Access Compliance Report Public Rights-of-Way (Curb Ramps)

Main Street: SMOKE_TREE_LN Cross Street: GIGI_DR Location: SW

ADA ID: RPRK211013151424 Ramp Type: Type 1 - Perpendicular Diagonal Initial Pass/Fail: Pass Overall Compliance: No Severity Score: 22

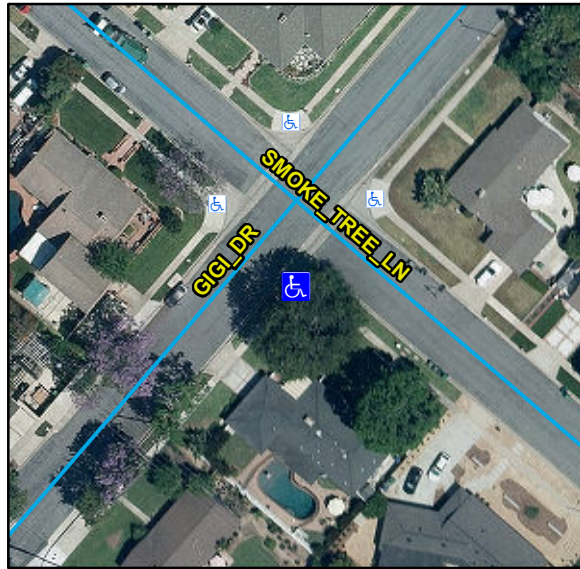
R304.2.1, R304.2.2-Perp, R304.3.2-Para, R304.5.3, R305, STD 1115

Remove & Replace Curb Ramp With Two New Directional Ramps or Equivalent.
